Access Compliance Report

Public Rights-of-Way

Intersection ID: 21454	Main Street: SARDIS_RD_NORTH	Cross Street: MAPLE_SHADE_LN	Location: NW
ADA ID: B711EA8E29D4	Ramp Type: PerpDiag	Initial Pass/Fail: Fail	Overall Compliance: No
Severity Score: 37.5			
Codes/Mitigation Info/Possible Solution		Field Measurements/Component Compliance

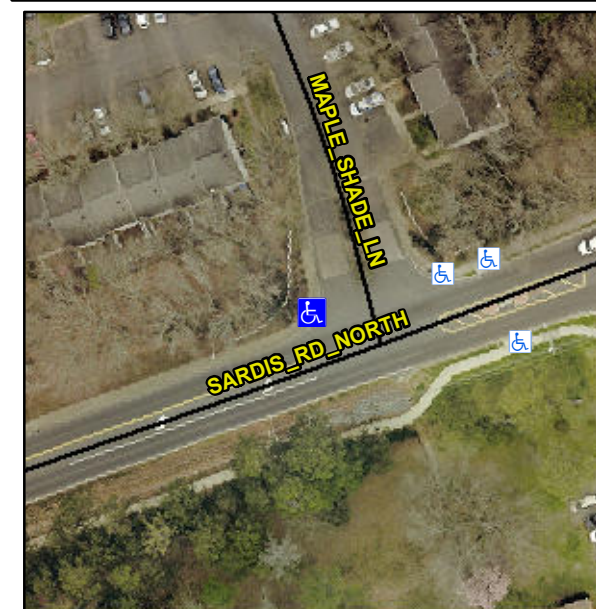
Remove & Replace Curb Ramp With Two New Directional Ramps or Equivalent.

R304.2.2, R304.5.3
